RE: RETAINING WALL FOR COTTONWOOD ESTATES SUBDIVISION

REF: GRADING AND DRAINAGE PLAN FOR COTTON WOOD ESTATES SUBDIVISION
(H22-D38) RECEIVED APRIL 17, 1984

REF: Grading and Drainage Plan for COTTONWOOD ESTATES SUBDIVISION
(H22-D38)

STORM DRAINAGE REPORT
FOR
COTTONWOOD ESTATES

It is proposed to develop the property as a 48 unit townhouse addition. The proposed development is superimposed on the City Orthotopo map in Figure 1.

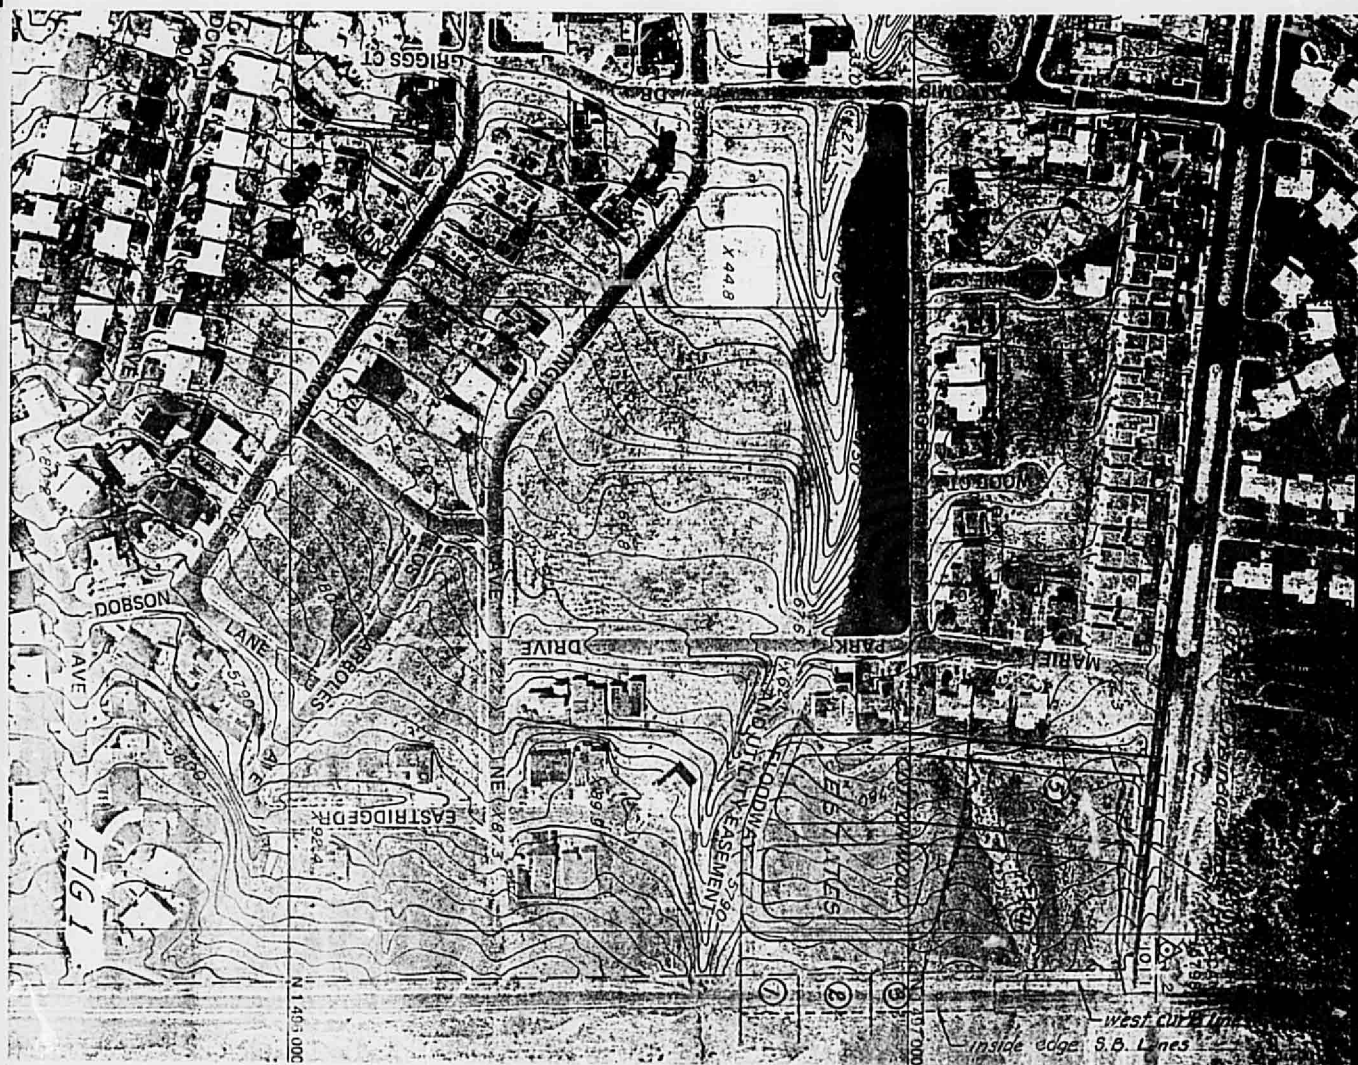
4. Figure one has been included in this submittal.
5. Where mountable curb is called out on the plan, no special treatment of the curb is necessary. Where standard curb is called out, curb cuts have been shown on the plan.
